MAG Standard Specifications and Details Committee
TENTATIVE AGENDA
April 8, 2015

MEETING MINUTES FROM THE
MARICOPA ASSOCIATION OF GOVERNMENTS
STANDARD SPECIFICATIONS AND DETAILS COMMITTEE

Subject: Revisions to Sections 336, 321.10.3, 601.2.7 and Detail 200-1

DETAIL NO.
2200

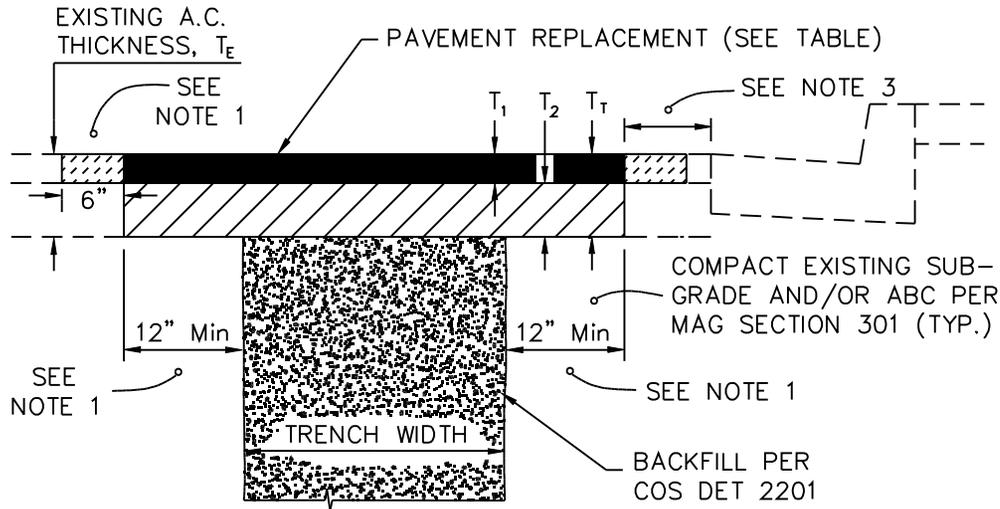
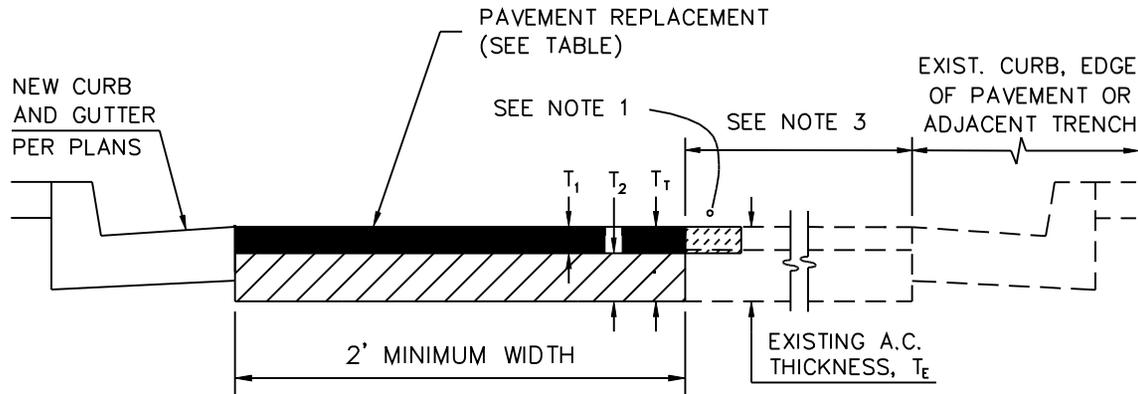
Comment [RTH2]: The asphalt match point shown in Detail 200-1 Type A Trench Repair needs to be revised to comply with this paragraph. See Scottsdale Detail 2200 for a suggested staggered joint modification.

Comment [RTH3]: This section will need to be modified to require staged removal of asphalt pavement for trenches similar to Scottsdale Detail 2200. Detail 2200 provides for re-compaction of the non-confined base course adjacent to the open trench.

DETAIL NO. TBD- 2	 MARICOPA ASSOCIATION of GOVERNMENTS	STANDARD DETAIL ENGLISH	RECLAMED WATER VALVE BOX INSTALLATION	REVISED 3/4/15 Draft	DETAIL NO. TBD- 2
-----------------------------	--	-----------------------------------	---	-------------------------	-----------------------------

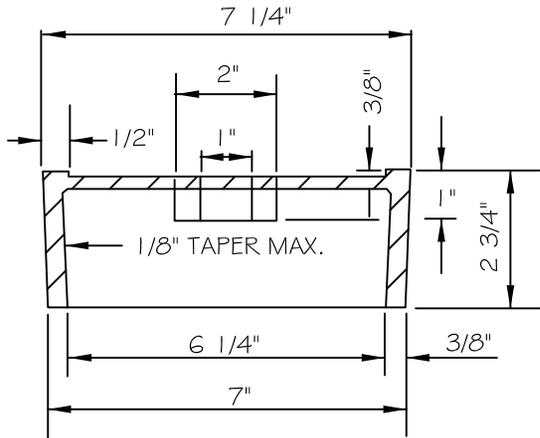
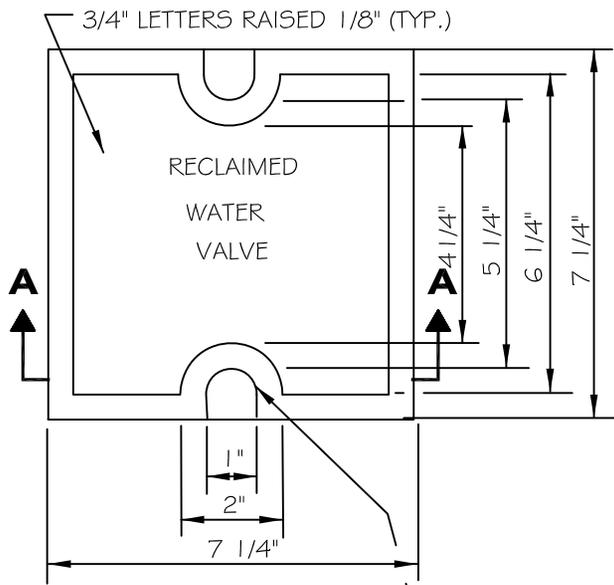
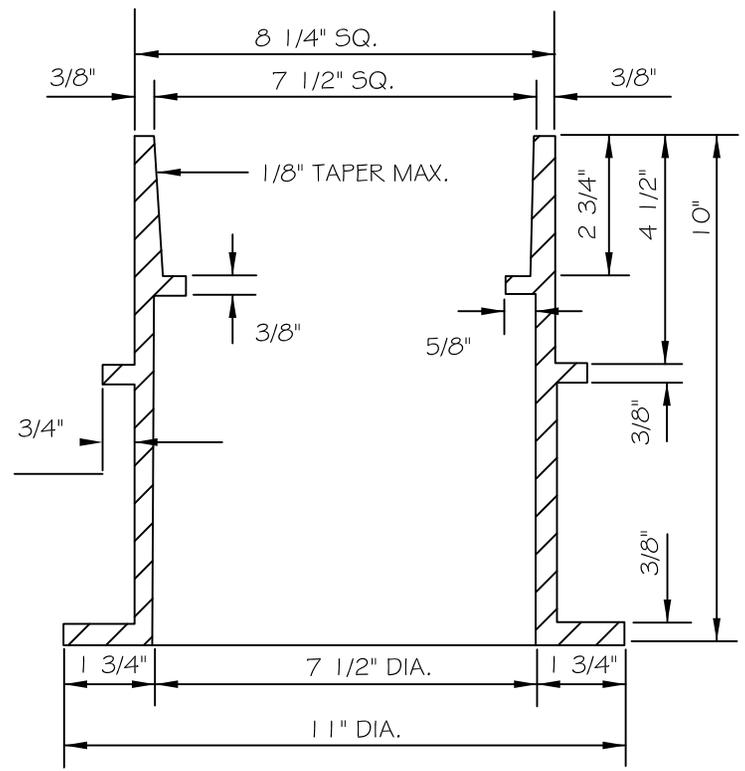
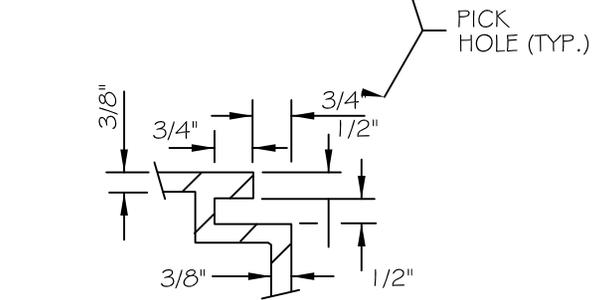
2. New Reclaimed Valve Box Detail No. TBD

See attached initial DRAFT for further development.

DETAIL NO.
C-237
NTS

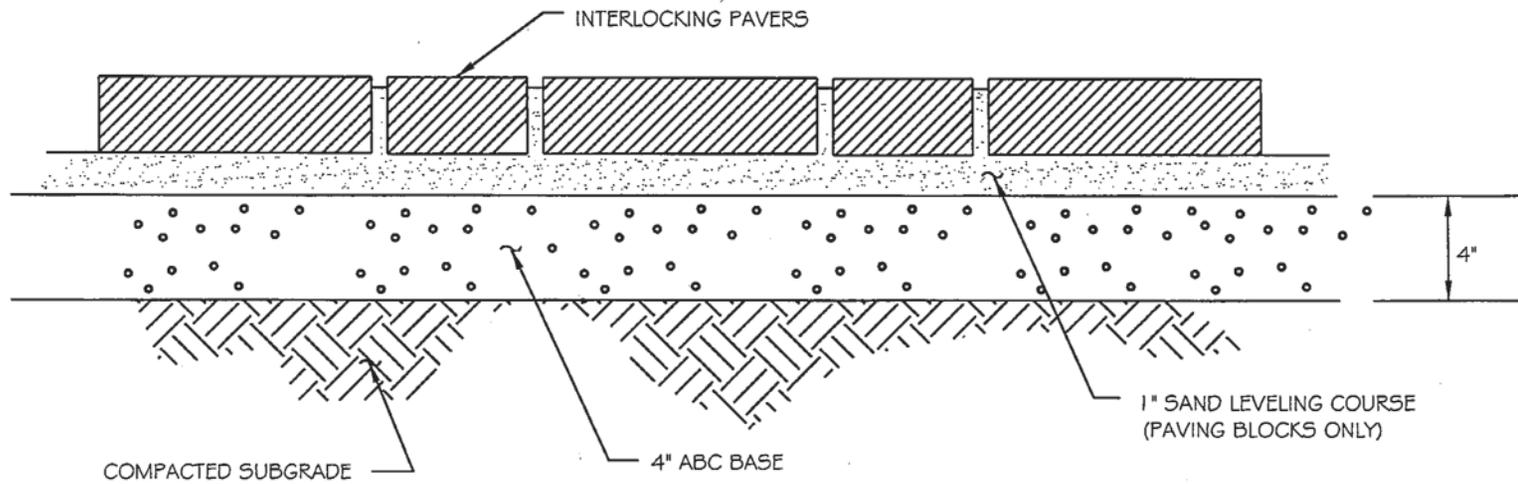
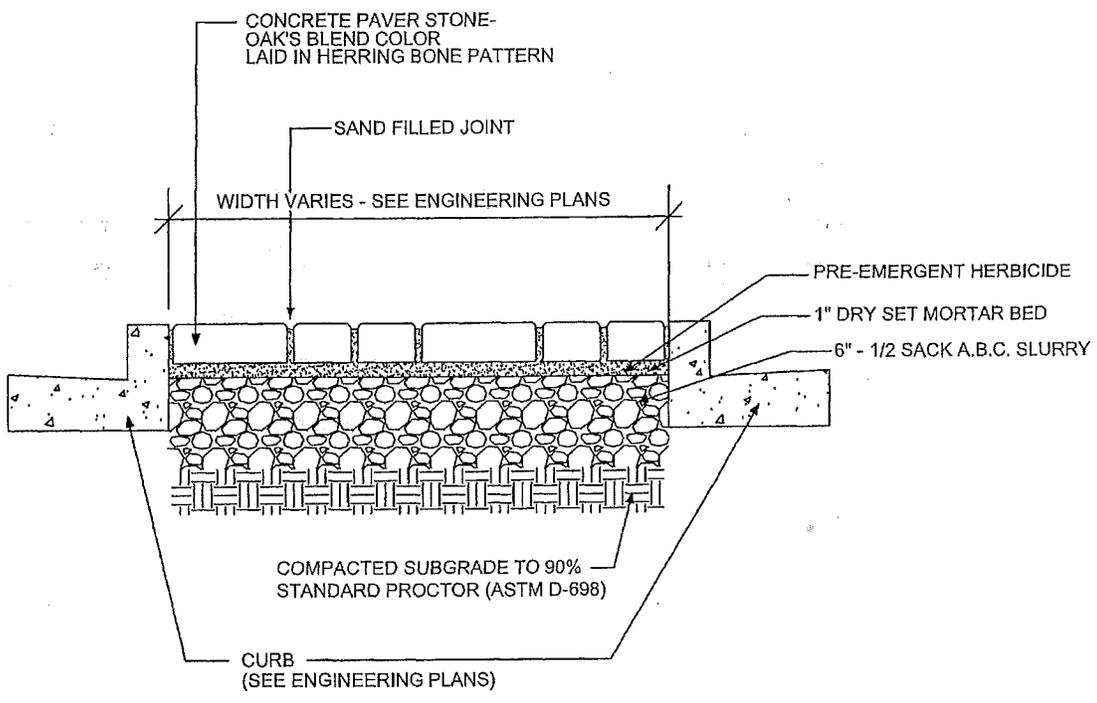
Make revisions to Detail 225 and Section 342. Warren White discussed a potential new case that would provide options for pavers that are in non-travel areas such as raised medians. The handout he provided included Chandler's detail as well as one from Glendale and language from the City of Phoenix supplement. He suggested modifying Section 342 and Detail 225. Tom Wilhite said it would be good to show the header where the pavers transition from paved to non-paved areas. Jim Badowich said they also have a supplement and saw no reason to have a concrete base under pavers in the median. Mr. White asked for thoughts on what to use instead. Half-sack slurry was a preferred material. Rod Ramos said Scottsdale has used a layer of asphalt that worked well. There was also discussion on the different sizes of bricks – 60mm and 80mm. The larger size typically is used for traffic areas. Mr. Ramos said private contractors often use silica sand.

1. Revision to C-225 Concrete Paver Detail to depict pavers/decorative concrete on ABC for raised medians or other non-traveled areas?
2. Revision to MAG Section 342 Decorative Pavement Concrete Paving Stone or Brick, Section 342.3 Construction Standards?
